Technical Service Bulletin

MODEL(S) AFFECTED: **T1 Corded Floor Scrubber, E5 Carpet Extractor and R3 ReadySpace Carpet Cleaner**

SUBJECT: If you are experiencing wall outlets equipped with ground fault circuit interrupter (GFCI)/residual-current device (RCD) tripping while operating machine, the brush motor(s) may be subject to current leakage due to excessive carbon brush dust buildup.

T1 Model Part Numbers
9004191 (120V)
9004195 (230V)

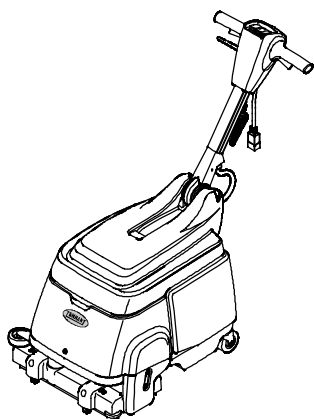
PURPOSE: If you have experienced the above condition, order new replacement motor, see list below, to resolve issue. The carbon brush holders are modified and a di-electric coating is included inside end-bell on new motor. The new brush motors were implemented into production starting in May through October of 2013.

New Brush Motor Replacement				
	<u>Models</u>	<u>120V Motor p/n</u>	<u>230V Motor p/n</u>	<u>Replacement Carbon Brush Kit</u>
	T1	1072719	1072720	1067897
	E5	1072719	1072720	1067897
	R3	1072721 (2)	1072722 (2)	1067897
